G70 BEQ Replacement CL

Marine Corps Base, Camp Lejeune, NC
Structural Interior Design Package
Sealed Final Submittal
May 2026

G703 BEQ Renovation CL
Marine Corps Base, Camp Lejeune, NC
Structural Interior Design Package

Project: Repair BEQ G703
Meeting: 50% Review Meeting
Date: December 2nd, 2025
Location: Microsoft Teams Meeting

I-101

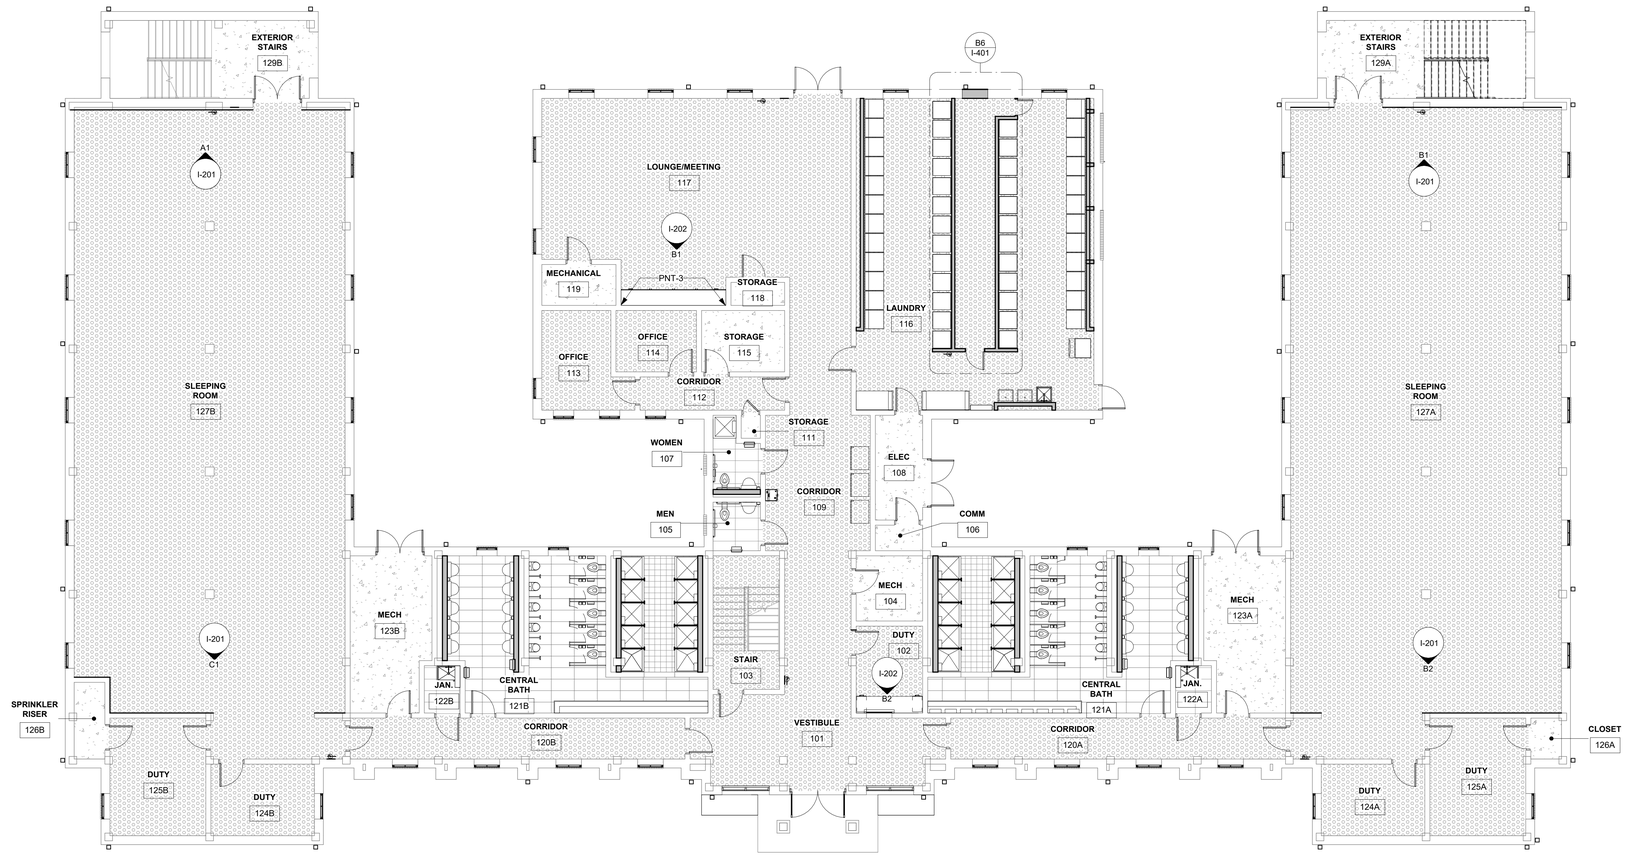
ID #2103251 Sheet I-101: G702 and G703 Do the showers in both/all central baths have the first two needing tile on the floor? As opposed to a solid-surface pan? Are all the showers to be tiled on the shower floors?

Response: Concur. Finishes will be updated.

I-111

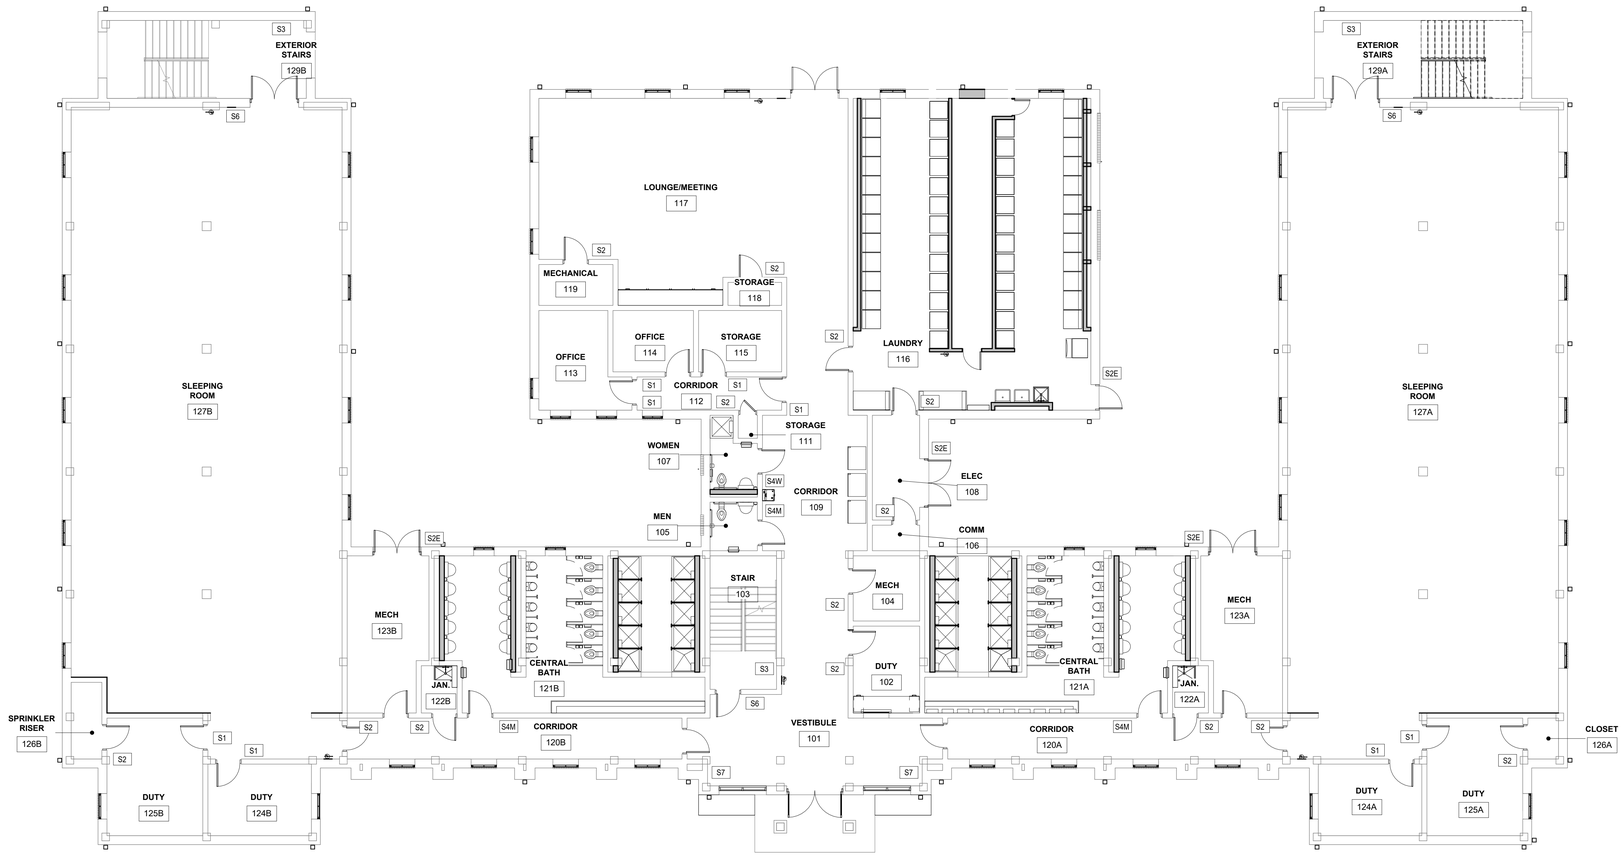
ID #2103256 Sheet I-111: G702 and G703 Fix double pasting of double doors leading to exterior stairwells.

Response: Concur. Extra door has been removed.
